<b>DRAINAGE PLAN FOR COTTONWOOD GROVE</b>	Design: KHB Drawn by: DLM Checked by: KHB Date: April, 1984 Job no:
	MID-KANSAS ENGINEERING CONSULTANTS PA 240 NORTH ROCK ROAD SUITE 130 WICHITA, KANSAS 67206 682-6561	Sheet: 1 of 1

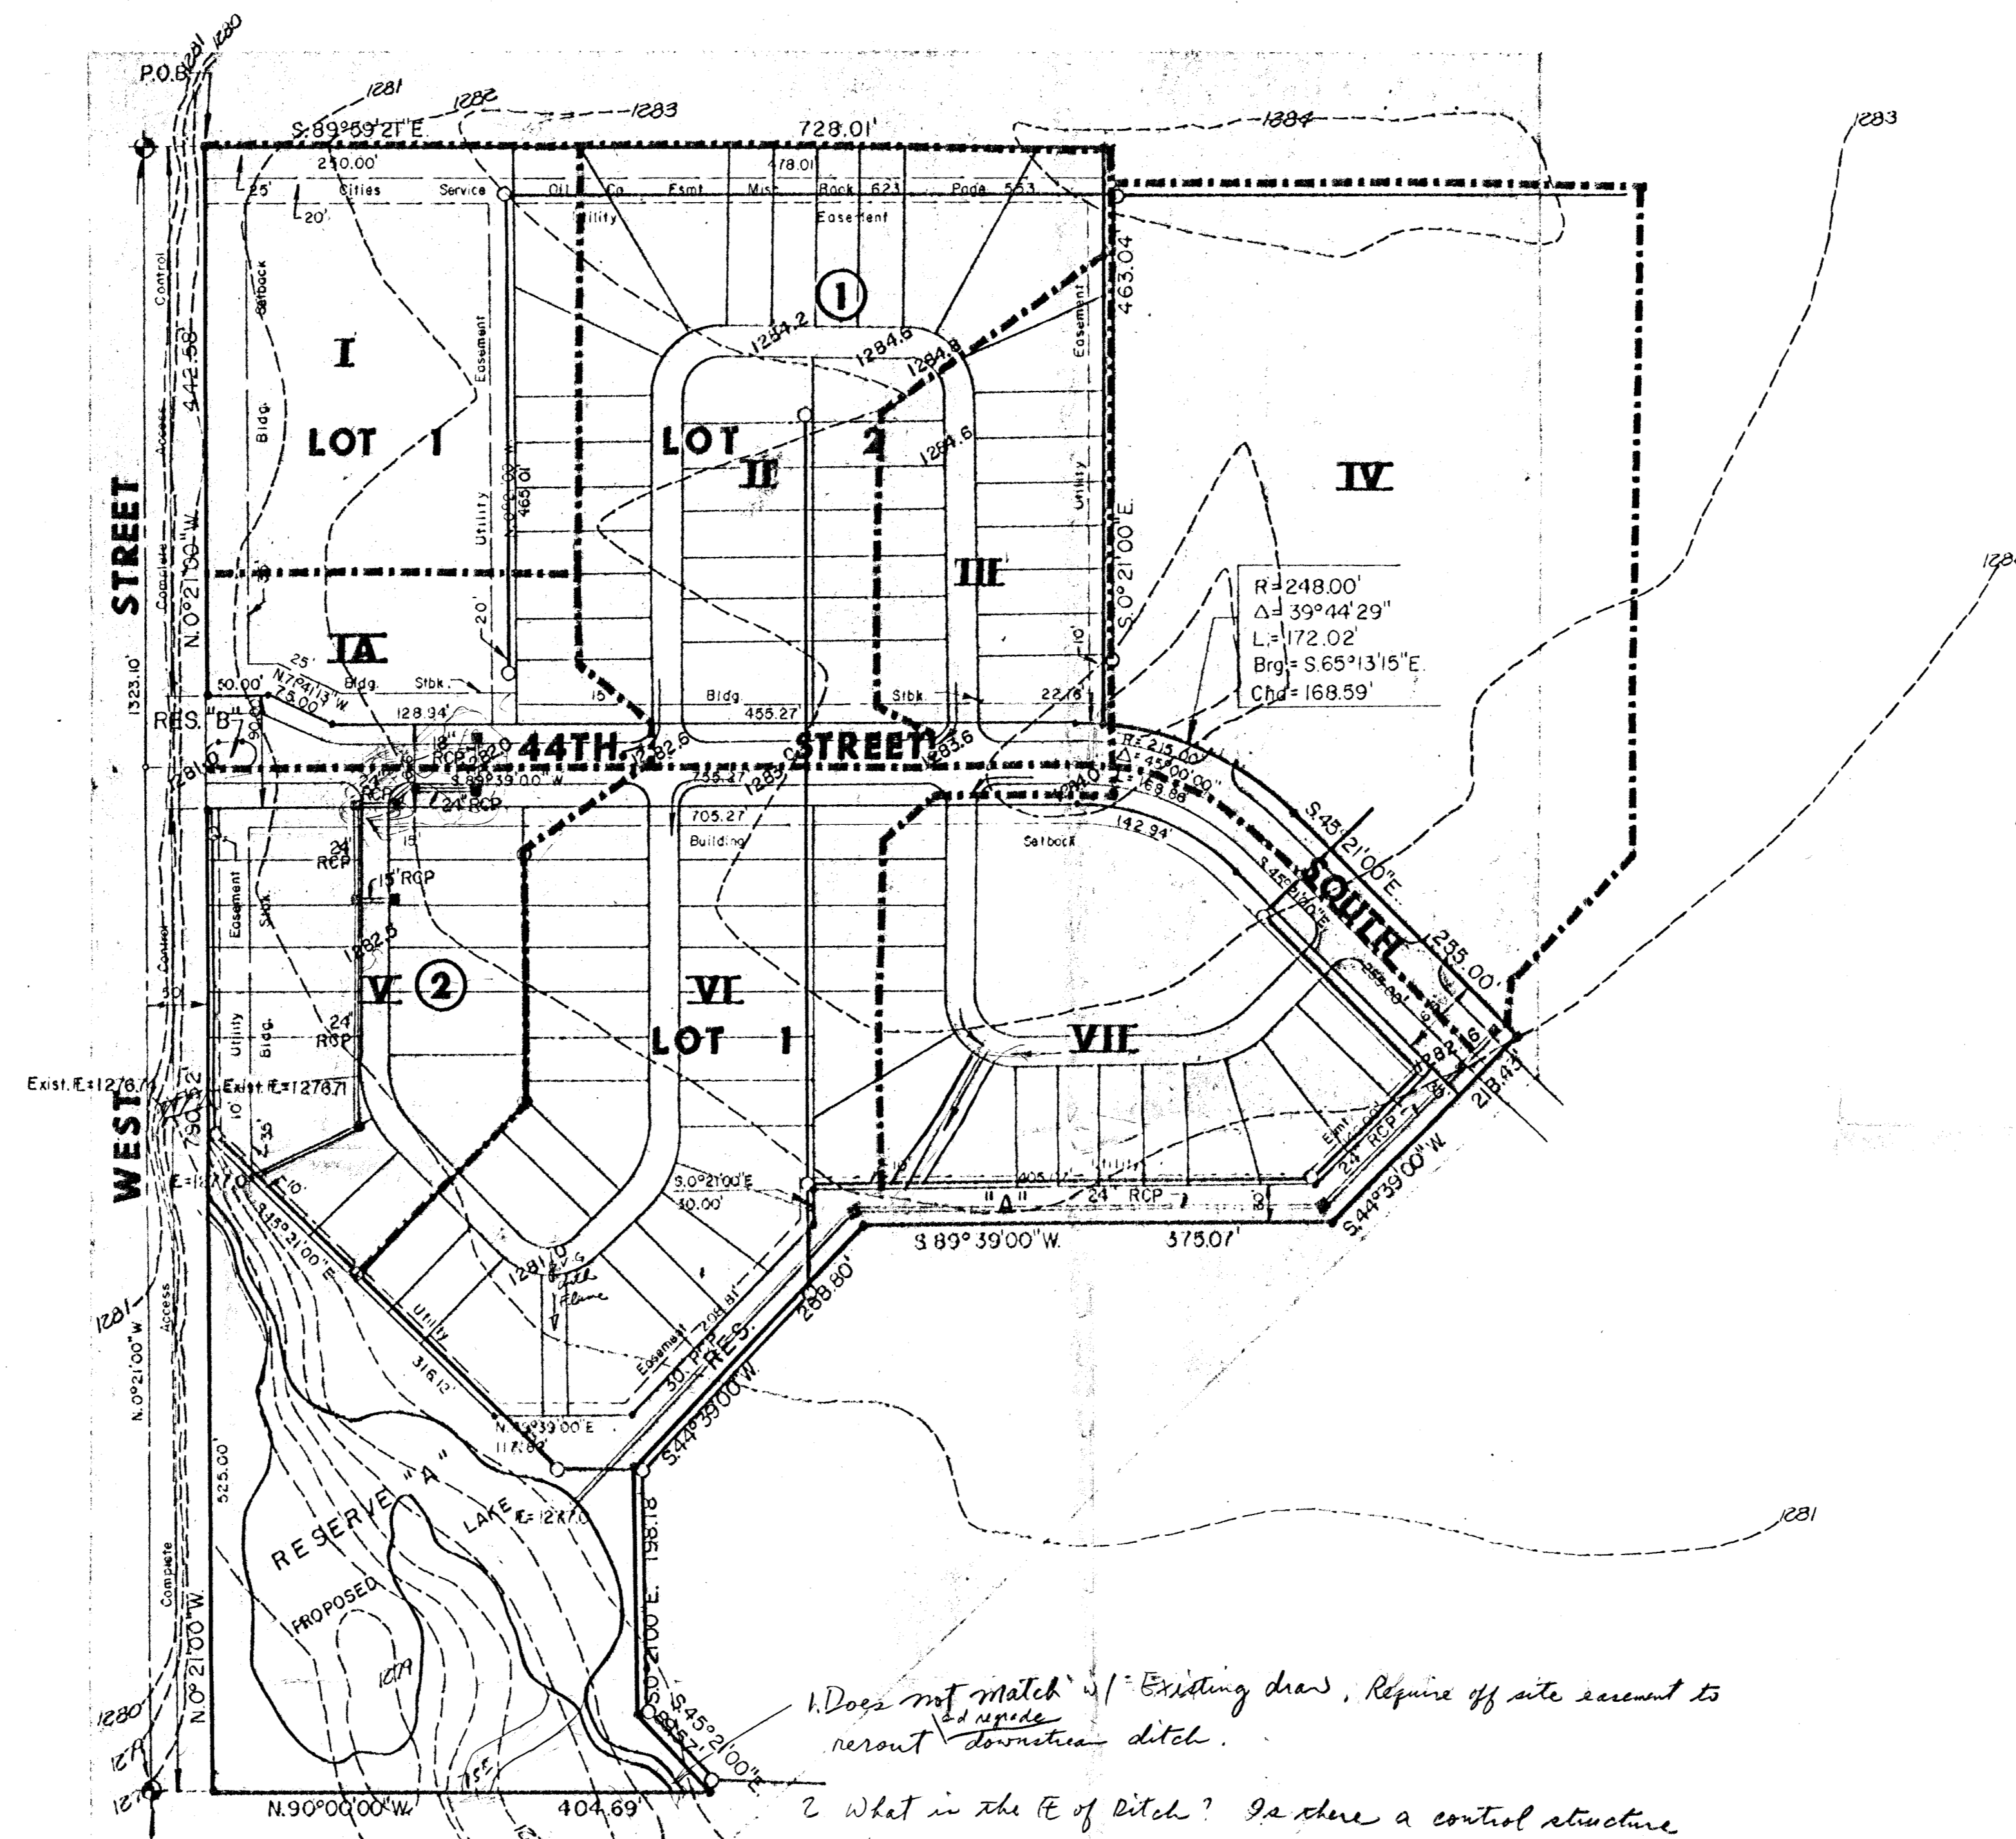
1. Does not match w/ Existing draw, require off site account to rerout domestic ditch.  
2. What is the E of Ditch? Is there a control structure at outlet of Pond?  
Part of Lot 2 drain across lot 1 and part of lot 1 drain to West St Ditch.  
Guarantee all drainage improvements.
